CSP 26-003KB (BP022) – ADDENDUM No.02
Gym Renovations and Additions

ADDENDUM

Addendum Number Two (02)
TO PLANS AND SPECIFICATIONS FOR
CSP 26-003KB BP022 Gym Renovations
Fort Bend ISD
STANTEC Project Nos.: 214001246

October 21, 2025

2 **PLUMBING ENLARGED DEMOLITION PLAN - LEVEL 1 - ART 306 & COMPUTER 305**
Scale: 1/4" = 1'-0"

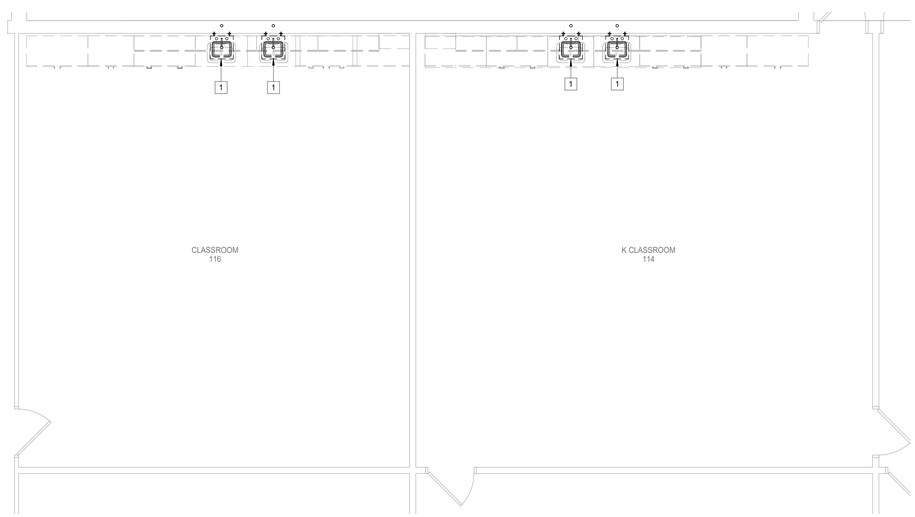
i. REVISED KEYED NOTE #1.
